Design Refinement 19 – Tangier Farm

Hampshire Water Transfer and Water Recycling Project
Consultation Information
Spring 2025 Consultation
Figure 40 Tangier Farm – Design Refinement

Figure 39 Tangier Farm – Summer 2024 Consultation design

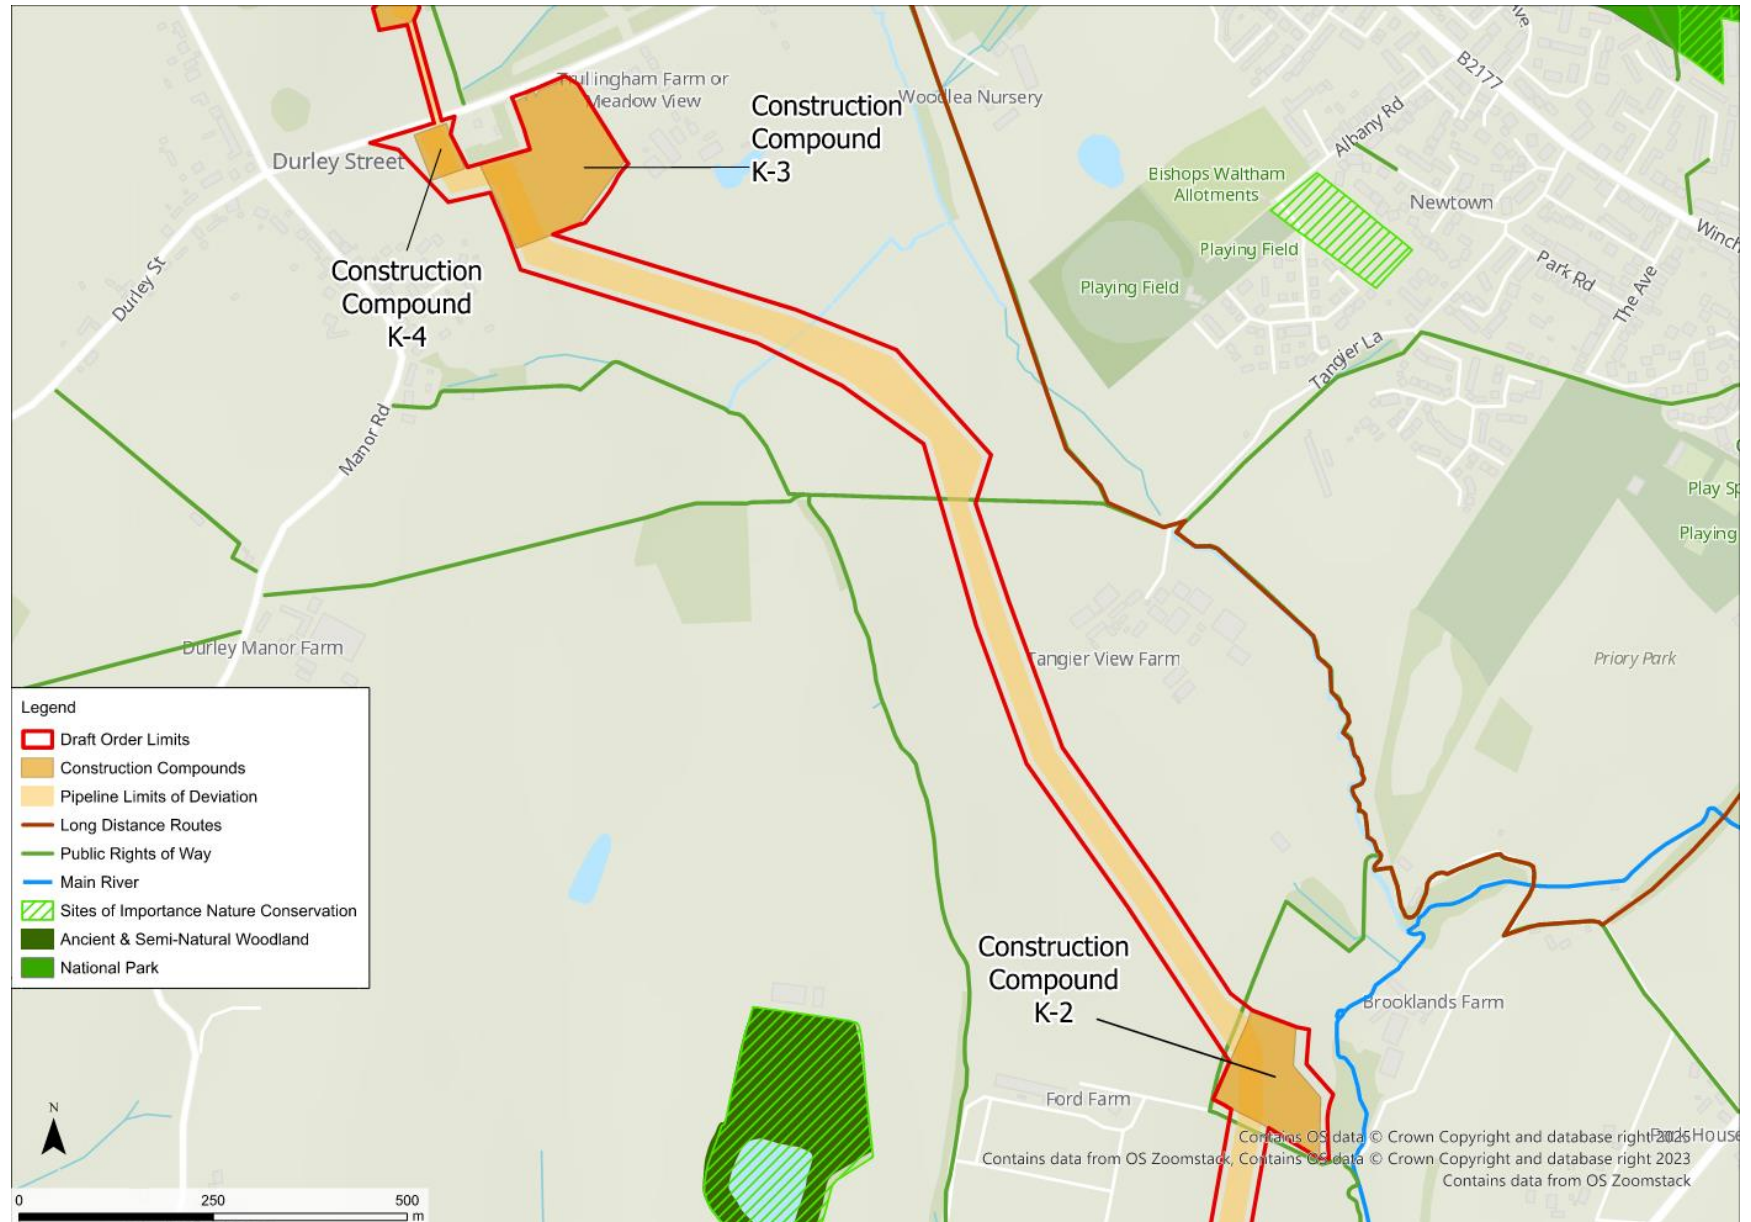
Feedback from our Summer 2024 Consultation identified that the pipeline route would have an impact on existing equine businesses and agricultural land in this area, as the pipeline route and construction works were located across the centre of multiple fields. When developing the design of the Project, we have aimed to reduce impacts on existing businesses.

We considered whether the pipeline route and construction works could be realigned to the edge of fields as far as reasonably practicable so effects on agricultural and equestrian uses could be minimised. We identified that the route could be moved to the south west without having any major impacts on the construction and operation of the pipeline, or the environment. We considered other options to amend the pipeline route in this area, but these would either constrain the construction and operability of the pipeline, or introduce new environmental impacts.

The design refinement is closer to trees and woodland associated with the Park Lug, which is an historic embankment and landscape feature, however, construction works will not result in the loss of vegetation along the Park Lug, and root protection areas for high value and mature trees will be avoided. This will avoid any additional impacts to this feature or the landscape character.

The design refinement will move the construction works closer to a Public Right of Way (Bishop's Waltham 44) that runs along the Park Lug. There is potential for an increase in temporary visual and noise effects on the users of this footpath compared to effects reported in our Preliminary Environmental Information Report presented at the Summer 2024 Consultation. Mitigation measures will however be implemented during the construction phase to reduce any effects.
